Request IR-1:

Please provide specific details on the criteria used and the work completed to determine the original scope of 77 structures requiring structure and conductor replacement.

Please provide a GIS map showing the overall L5031 transmission line path, identifying the locations of the deteriorated structures being replaced under the original scope, the additional structure replacements, the mobile substation, and the bypass structures.

L5031-000 to L5031-075 Phase 2 Scope Drawing (includes location of the 3 by-pass structures)

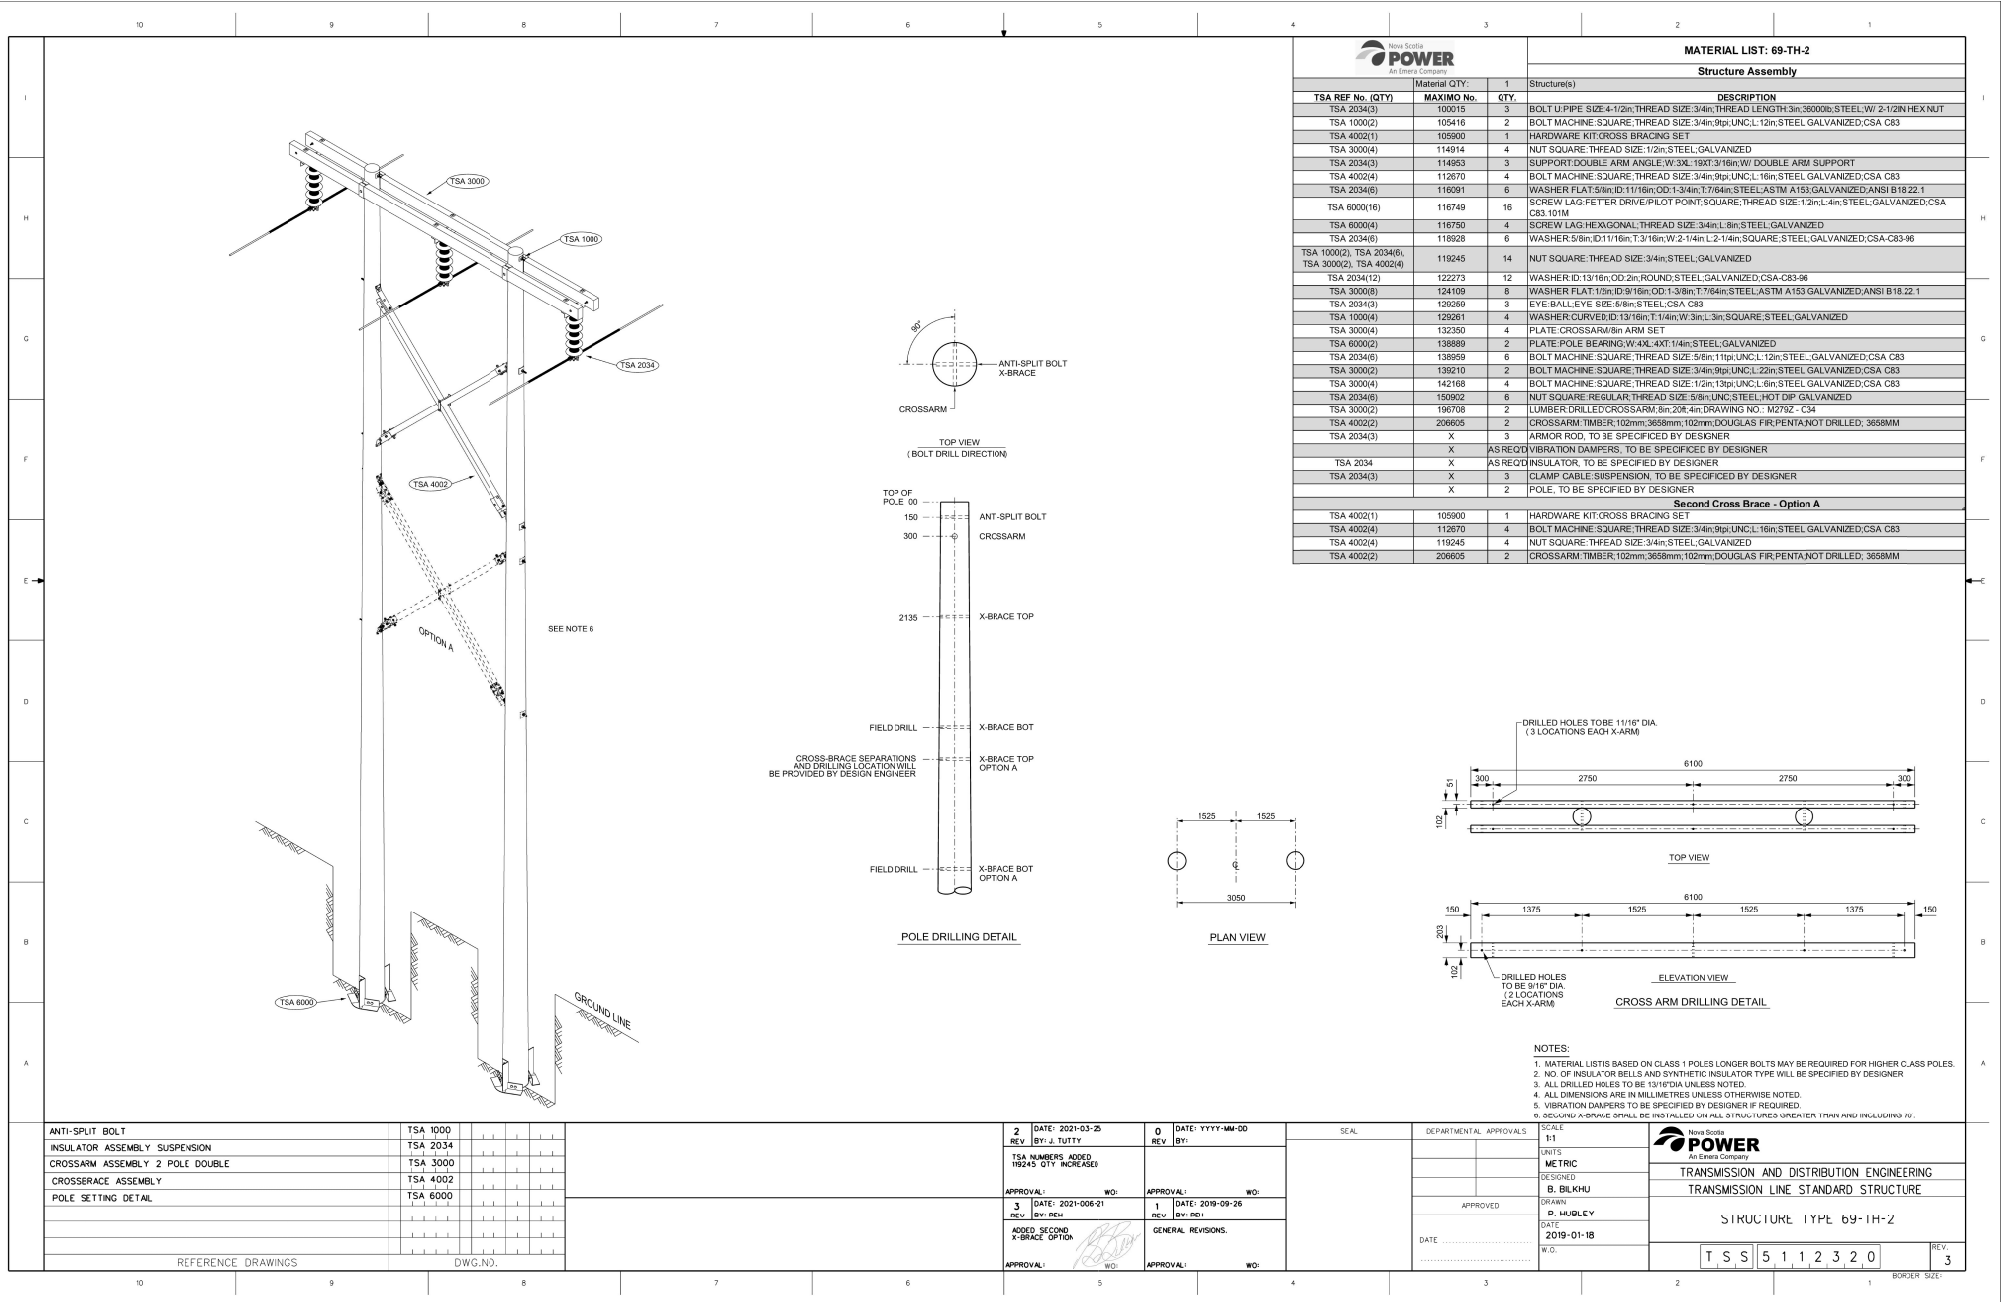
(a) Please describe the components of 69kV transmission line structure and provide NS Power’s standards and drawings to support the explanation.

(a) The existing L-5031 transmission line consists of wood pole structures, insulators, and a combination of 336.4 kcmil ACSR Linnet and 1/0 ACSR Raven conductors. Please refer to Attachment 1, which illustrates a typical 69 kV wood pole transmission structure standard. Today’s updated standard would look similar to the original drawings used, however, the original drawings used during the period in which the line was originally constructed in 1966 are not available.

NS Power now designs and constructs new 69kV transmission lines to 138 kV standards. Accordingly, the replacement L-5031 transmission line has been designed and will be
